Power Supply Adapter Replacement On Certain Development Boards

XCN08015 (v1.0.1) May 23, 2008

Quality Alert

Figure 1: Example Non-compatible power supply adapter
(May not represent exact configuration in all cases)

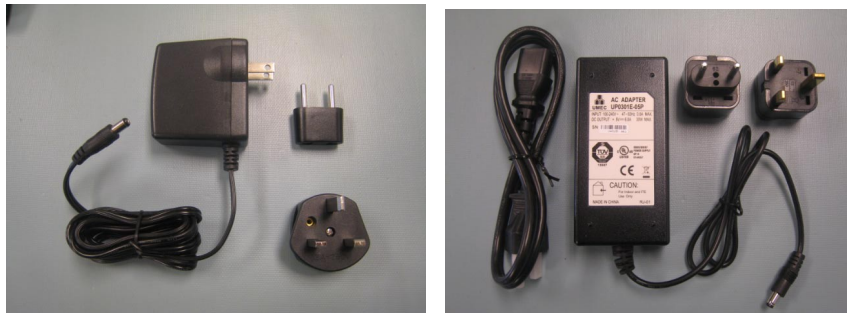
The affected products include a two-blade NEMA plug and a separate cord-to-wall adapter, as shown in the figures below. The photos below are intended for reference and will not illustrate every configuration.

Figure 2: Example New compatible power supply solution
(May not represent exact configuration in all cases)
